**To:** Board of Managers: Nine Mile Creek Watershed District  
**From:** Barr Engineering Company  
**Subject:** Permit #2018-90: Normandale Lake Drawdown: Bloomington  
**Date:** July 16, 2018

**To:** Randy Anhorn, NMCWD Administrator  
**From:** Shanna Braun and Janna Kieffer  
**Subject:** Normandale Lake Drawdown Project- NMCWD Permit Application  
**Date:** July 16, 2018

**To:** Jason Spiegel, Minnesota Department of Natural Resources  
**From:** Janna Kieffer, Barr Engineering  
**Subject:** Hydraulic Analysis of Proposed Temporary Weir in Nine Mile Creek upstream of Normandale Lake  
**Date:** June 1, 2018  
**c:** Erica Sniegowski, Nine Mile Creek Watershed District  
Randy Anhorn, Nine Mile Creek Watershed District

Figure 1. Nine Mile Creek upstream of West 84<sup>th</sup> Street

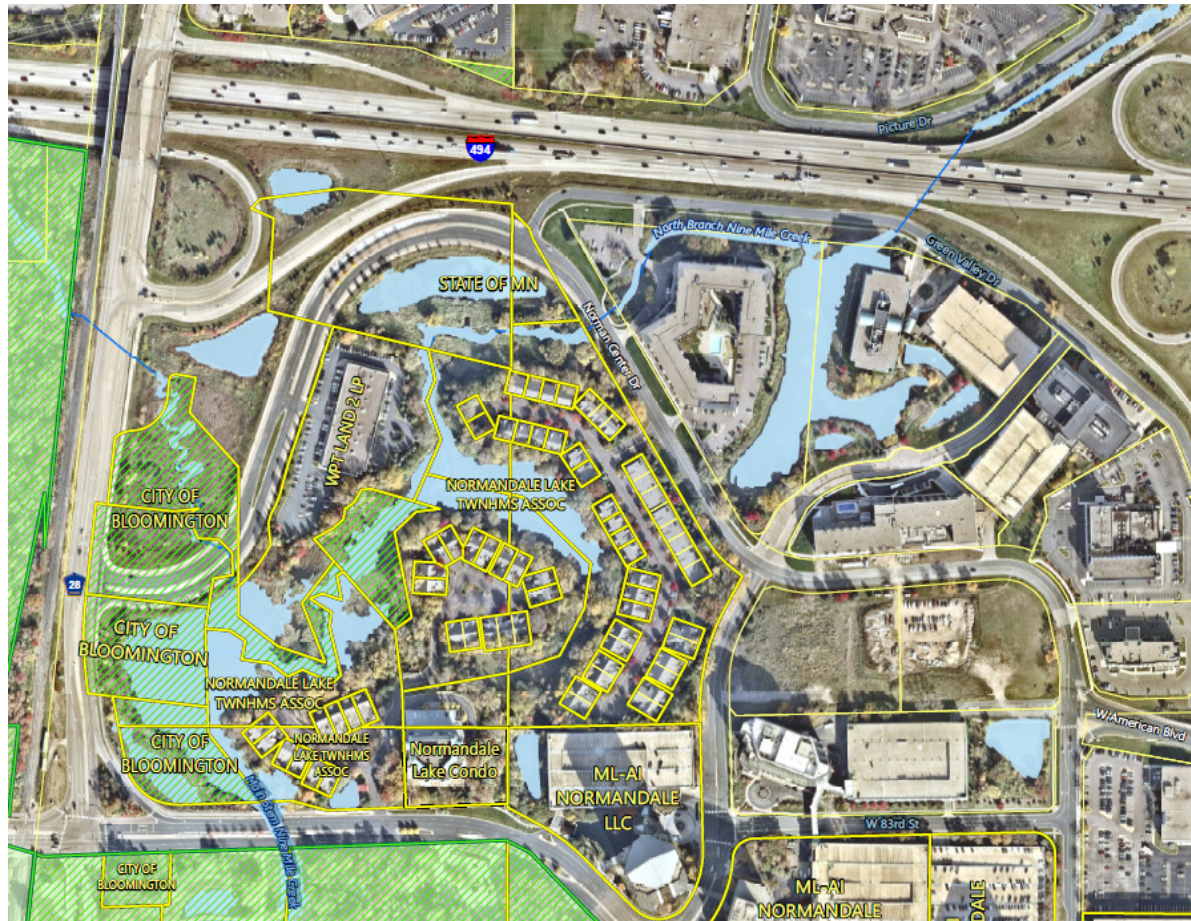
Figure 1 shows the area between I-494 and West 84th Street. Review of LiDAR elevation data indicates that no structures are within the 100-year floodplain in these areas under existing or proposed (i.e. with the temporary weir) conditions. The 100-year flood elevations under proposed conditions are below the District's historic flood management elevations for all locations evaluated.

The properties adjacent to Nine Mile Creek in the area shown in Figure 1 were developed in 1999 or later. Although the NMCWD policies and rules have changed considerably since 1999, the policies and rules since 1999 have required that low floor elevations of structures be at least two feet above the Nine Mile Creek flood management elevation. Accordingly, the structures of properties adjacent to Nine Mile Creek in the area upstream of West 84th Street that required a NMCWD permit were to provide at least two feet of freeboard from the 100-year flood elevation. No new structures, as defined by the current NMCWD rules, or stormwater management facilities are being constructed as part of this proposed project.

Plan sheet C-05

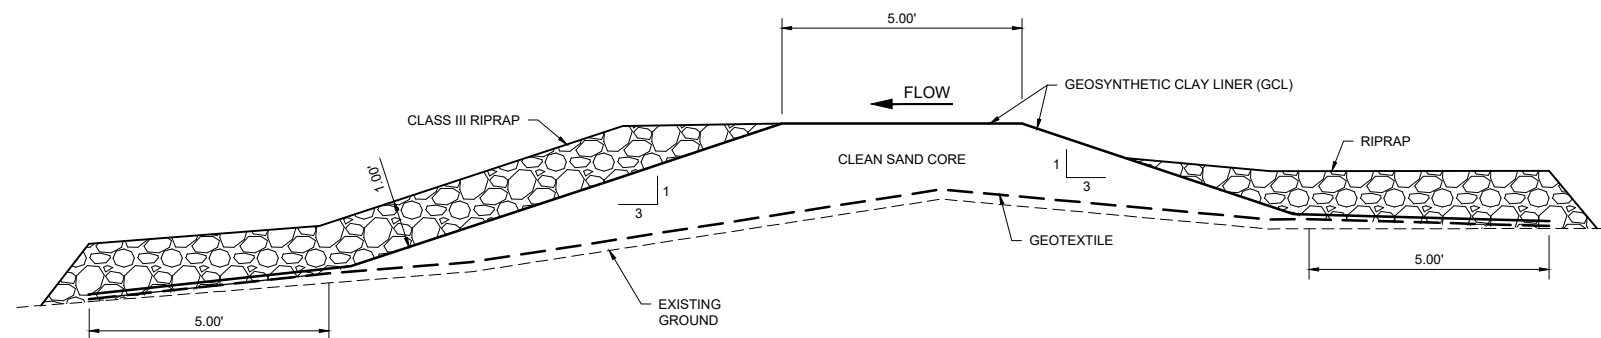
The proposed temporary weir was incorporated into the "proposed conditions" model based on the design shown on Sheet C-05 of the NMCWD Normandale Lake Drawdown preliminary (60%) design drawings (attached). The proposed weir consists of an earthen berm of approximately 40 feet in length across the channel just upstream of the existing footbridge at elevation 808.1 feet MSL (control elevation of existing Normandale Lake outlet weir), with a 20 foot notch in the weir at 807.7 feet MSL. The "notch" will be centered in accordance with the existing Nine Mile Creek stream centerline, with the intent of channelizing the conveyance of baseflows (approximately 5 cfs) and reducing the potential for downstream erosion.
